Product Change Notice (PCN)

PCN Number: **PCN-0455137R-01**

Product(s) Affected: *PJ-059AH*

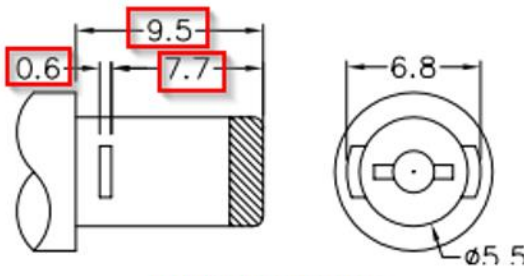
Description of Change: *Minor Housing and footprint differences. Material Change on the housing and terminals. See image Below*

PREVIOUS CUI DEVICES DETAIL / IMAGE			NEW CUI DEVICES DETAIL / IMAGE		
	MATERIAL	PLATING	DESCRIPTION	MATERIAL	PLATING/COLOR
center pin	copper	nickel	center pin	brass	nickel
terminal 1	brass	silver	terminal 1	brass t=0.30	silver
terminal 2	copper alloy	silver	terminal 2	bronze t=0.25	silver
terminal 3	brass	silver	terminal 3	brass t=0.30	silver
plastic	PBT		cover	PBT (UL94V-0)	black
			housing	PBT (UL94V-0)	black

MATING PLUG
Jack Insertion Depth: **9.8 mm**

MATING PLUG
Jack Insertion Depth: **9.5 mm**
